General Bid Bulletin No. 25
28 May 2021

IFB NO. 20-031-6

SOUTH COMMUTER RAILWAY PROJECT
FOR PACKAGES CP S-04, CP S-05, CP S-06 AND CP S-07
CONSTRUCTION OF CIVIL STRUCTURES: VIADUCTS, BRIDGES,
NINE (9) STATIONS AND DEPOT

CP S04-07 Responses to Clarification Requests (Batch 15)

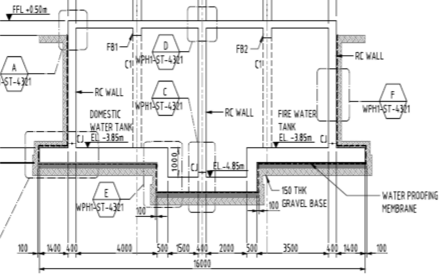
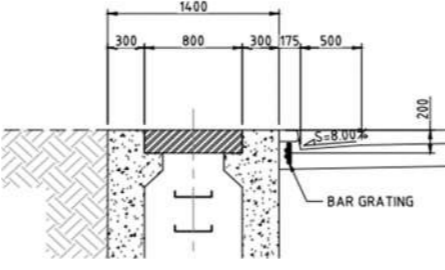
S-04		Vol. 2 Part 2 Sec IC TS 500	TS 500 - 246	523 Tensile Membrane Roof Structure (TMRS)	TMRS, PTFE	In reference specification for TMRS, "Membrane supplier has experience of manufacturing and installing polytetrafluoroethylene(PTFE) tensile membrane structures for over twenty (20) years all over the world (including the Philippines), and has installed at more than twenty (20) MRT stations by using TiO2 membrane roof structure." Only one specific subcontractor will be available to satisfy the above specification. If the contractor shall comply strictly with this specification, there is no choice but to place a order this works to a single subcontractor without competition. Therefore, please clarify whether the contractor shall comply with this specification. Or, please clarify whether it will be possible to mitigate the specification for competition with more than three subcontractors.	<i>Membrane supplier has experience of manufacturing and installing polytetrafluoroethylene (PTFE) tensile membrane structures for over twenty (20) years all over the world (including the Philippines), and has experience in installation of TiO2 membrane roof structure, subject to Engineer's approval; Amended TS 523.1.1 is in Addendum 5</i>

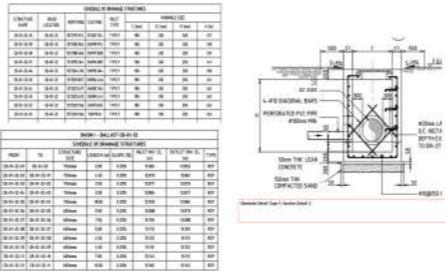
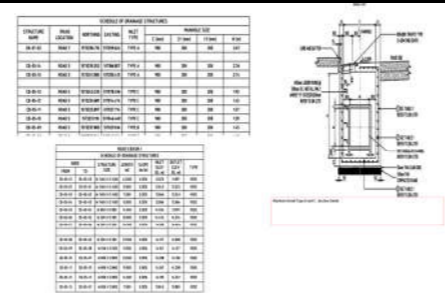
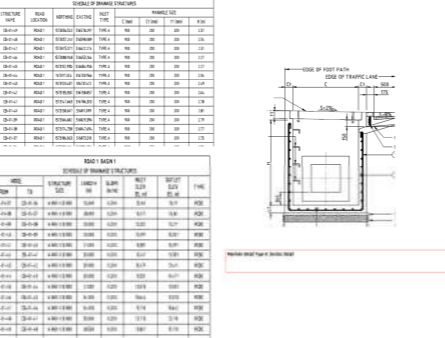
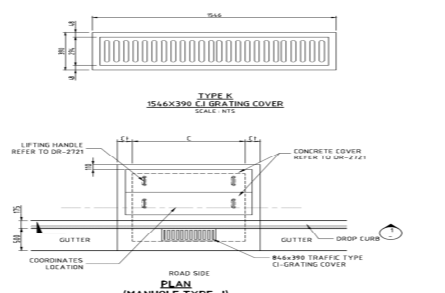
S-05		-	2	TS Update Table Batch 05 Query No.721 TS 201 Annex A	"Shored excvation measured by offset of 1meter both side from the face of the structure and the total depth is measured from bottom of lean concrete up to the existing ground level. Open excavation is not applicable due to limited ROW."	Based on the drawings reference no.NSRP-DWG-VIA05-ST-0301, contractor shall install 200mm THK crushed gravel below the lean concrete. As we understand, contractor shall excavate upto bottom level of crushed gravel, please clarify these volume of excavation considered the measurement or not.	Bidder is advised to refer to TS 201.1.1.1 in Addendum 4.
S-06		Vol. 2 Part 2 Sec IC TS 500	TS 500 - 246	523 Tensile Membrane Roof Structure (TMRS)	TMRS, PTFE	In reference specification for TMRS, "Membrane supplier has experience of manufacturing and installing polytetrafluoroethylene(PTFE) tensile membrane structures for over twenty (20) years all over the world (including the Philippines), and has installed at more than twenty (20) MRT stations by using TiO2 membrane roof structure." Only one specific subcontractor will be available to satisfy the above specification. If the contractor shall comply strictly with this specification, there is no choice but to place a order this works to a single subcontractor without competition. Therefore, please clarify whether the contractor shall comply with this specification. Or, please clarify whether it will be possible to mitigate the specification for competition with more than three subcontractors.	Membrane supplier has experience of manufacturing and installing polytetrafluoroethylene (PTFE) tensile membrane structures for over twenty (20) years all over the world (including the Philippines), and has experience in installation of TiO2 membrane roof structure, subject to Engineer's approval; Amended TS 523.1.1 is in Addendum 5

S-05		Vol.2	GS - 93	GS 125 LIAISON WITH OTHERS	The Contractor shall make all necessary arrangements with and obtain all necessary approvals from Government departments, utility agencies and other relevant/competent authorities.	Please confirm who will pay for the incoming fee of water, power, and communications.	Bidder is advised that payment for obtaining all necessary approvals and permits from Government Agencies rests with the Contractor.
S-05		Vol 2. Sec.6 IB Appendix 15	3	4D Modeling	Update to include 4D modeling for SC Contract Packages Only	The BIM Information Management published in Addendum 2 contains contents related to 4D model. Does the employer's BIM requirement include 4D model? Then, when and how many times does contractor have to submit the 4D model? Please check the exact BIM requirements.	4D model will be used for visualization purposes only and will be submitted upon request of the Employer.

S-05		Vol 3.	Section 8 Attachment 1	Summary of Key Dates		Which Key Date shall be applicable for completion of Drainage System and Maintenance Road?	Bidder shall refer for the Completion fo Drainage System and Maintenance Road to the Key Date 08.
S-05		Vol 3.	Section 8 Attachment 1	Summary of Key Dates	KD 02-1, KD 02-2, KD 02-3 "... Continuous 3,000 / 6,000 / 9, 000 metres...."	Please clarify that the length of continuous viaduct means sum of the length of all single line track. e.g) where 3 line tracks is, continuous viaduct length = length of North Bound viaduct + length of Main line viaduct + length of South Bound viaduct	The wording of KD has been amended in Addendum 3. The length of continuous viaduct means the length of viaduct in single structure not measured by length of track.
S-06		CP S-06	GS - 93	GS 125 LIAISON WITH OTHERS	The Contractor shall make all necessary arrangements with and obtain all necessary approvals from Government departments, utility agencies and other relevant/competent authorities.	Please confirm who will pay for the incoming fee of water, power, and communications.	Bidder is advised that payment for obtaining all necessary approvals and permits from Government Agencies rests with the Contractor.

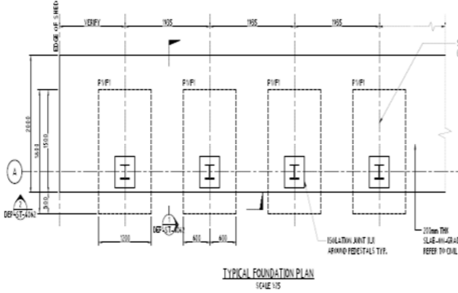
S-07		GBB 14	Page 68 of 76	TS 201 Structural Excavation and Backfill	Please refer to TS Annex PINS submitted February 2,2021. 201(4)e Foundation Fill	Backfill materials are from excavated materials or selected borrow materials while foundation fill are granular materials. 1) Please provide pay item for foundation fill	The Bidder is advised that there is no required foundation fill as per the drawings.

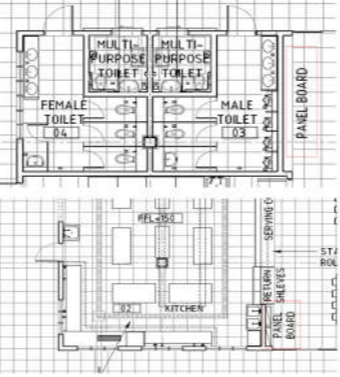
S-07		GBB 16 Volume 2, 02 Book 1 (CIVIL), 04 CP S07 DPSFE	Page 28 of 93 151	NSRP-DWG-DEP-DR-2709 As per BB 16 response, Refer to TS 111 MANHHOLES, INLETS AND CATCH BASINS. Manhole Detail Type I		As per TS 111, Frames, Gratings Covers and Lader Rungs - Metal units shall conform to the drawing dimensions and to the following Specifications: Metal Gratings, Pre Cast Concrete Units. 1. There are no type of manhole not indicated in the drawing. Please provide details and specification of cover 2. There is a difference in the dimension in the schedule and in the detailed drawings. Which shall govern? Based on the shedule , Ct = 0.25 & 0.20 Based on the standard details Type I, Ct=0.30	1. Manhole types are indicated in DR-2015 to DR-2023, manhole cover details are in DR-2721 2. Ct is 0.30 in NSRP-DWG-DEP-DR-2015, revised as 21.3

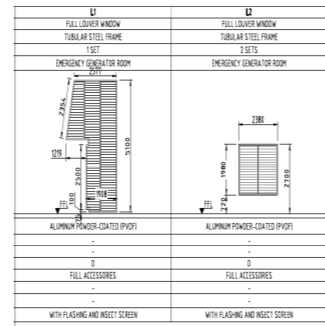
S-04		Volume 2 Section 6 IC - Technical Specification	53 of 372 & 65 of 372	204.2.6.4 & 204.4.12	<p>In 204.2.6.4, the number of piles to be tested by this method shall be 3% of all piles or as directed by the Engineer.</p> <p>In 204.4.12, the Contractor shall install access tubes for CSL testing in all bored piles, except as otherwise noted.</p>	<p>The required number of cross hole sonic logging (CSL) testing is 3% of all piles or as directed by the Engineer in TS200, 204.2.6.4. According to this specifications, the contractor install access tubes for cross-hole sonic log testing as mentioned TS200, 204.3.8 for only mentioned number of pile directly by the Engineer.</p> <p>Please confirm.</p>	<p><i>Yes, 3% of all piles or as directed by the Engineer will be tested (CSL) as per TS 204.2.6.4.</i></p> <p><i>The access tube to be installed for CSL testing in all bored piles except as otherwise noted. One access tube shall be furnished and installed for each foot of shaft diameter rounded to the nearest whole number as shown on drawings. A minimum of three (3) tubes shall be required or as specified on the drawings. The access tubes are included in the unit rate of pay item 204(7) Cross hole sonic logging test..</i></p>

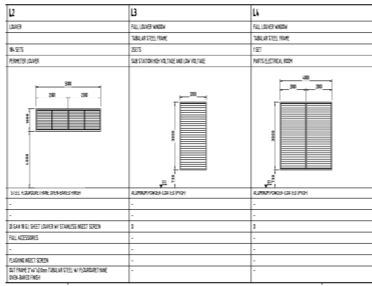
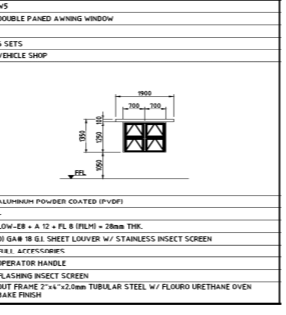
Item #	Doors & Windows	Unit	BOQ Qty	Qty based on Plan	D20C01	D20 for OCC Building, 1820mm x 1820mm, Double Leaf Fire Rated Steel Flush Door, Fluorescent Baked Finish	ea	36	60	D20C02	D4 for OCC Building, 1820mm x 1820mm, Single Leaf Fire Rated Steel Flush Door, Fluorescent Baked Finish	ea	20	11	D20C03	D5 for OCC Building, 1820mm x 1820mm, Single Leaf Fire Rated Steel Flush Door, Fluorescent Baked Finish	ea	19	21	D20C04	D6 for OCC Building, 1820mm x 1820mm, Single Leaf Fire Rated Steel Flush Door, Fluorescent Baked Finish	ea	38	13	D20C05	D7 for OCC Building, 1820mm x 1820mm, Single Leaf Fire Rated Steel Flush Door with Bottom Louver, Fluorescent Baked Finish	ea	36	22	D20C06	D8 for OCC Building, 1820mm x 1820mm, Single Leaf Fire Rated Steel Louver Door, Fluorescent Baked Finish	ea	15	11	D20C07	D9 for OCC Building, 1820mm x 1820mm, Interior Fixed Viewing Window, Stainless Steel Mullion Finishing	ea	12	8	D20C08	The Window Sill System or Cant Key System	mt	264	211	Please verify conflict in quantity of the following doors and windows	The updated BoQ is matched with the Schedule of Doors and Windows with the following reference sheets: NSRP-DWG-OCC-AR-3611 Rev 21.3, NSRP-DWG-OCC-AR-3612 Rev 21.2, NSRP-DWG-OCC-AR-3631, 3632, 3633 Rev 21.3, NSRP-DWG-OCC-AR-3641, 3642 Rev 21.2. Updated BOQ and Drawings shall be issued as Addendum No.3
Item #	Doors & Windows	Unit	BOQ Qty	Qty based on Plan																																																
D20C01	D20 for OCC Building, 1820mm x 1820mm, Double Leaf Fire Rated Steel Flush Door, Fluorescent Baked Finish	ea	36	60																																																
D20C02	D4 for OCC Building, 1820mm x 1820mm, Single Leaf Fire Rated Steel Flush Door, Fluorescent Baked Finish	ea	20	11																																																
D20C03	D5 for OCC Building, 1820mm x 1820mm, Single Leaf Fire Rated Steel Flush Door, Fluorescent Baked Finish	ea	19	21																																																
D20C04	D6 for OCC Building, 1820mm x 1820mm, Single Leaf Fire Rated Steel Flush Door, Fluorescent Baked Finish	ea	38	13																																																
D20C05	D7 for OCC Building, 1820mm x 1820mm, Single Leaf Fire Rated Steel Flush Door with Bottom Louver, Fluorescent Baked Finish	ea	36	22																																																
D20C06	D8 for OCC Building, 1820mm x 1820mm, Single Leaf Fire Rated Steel Louver Door, Fluorescent Baked Finish	ea	15	11																																																
D20C07	D9 for OCC Building, 1820mm x 1820mm, Interior Fixed Viewing Window, Stainless Steel Mullion Finishing	ea	12	8																																																
D20C08	The Window Sill System or Cant Key System	mt	264	211																																																
S-07		Volume 1 Addendum 2, 1.3 CP S-07 Vol.1A Sec.4A BOQ 20210310, BILL OF QUANTITIES No. 4-3.2	1 of 1	BILL OF QUANTITIES No. 4-3.2, Pedestrian Shed	Pedestrian Shed Catch Basin 	Please provide pay item for catch basin	Already included in the BOQ, Bill No.5, Part C Drainage Works
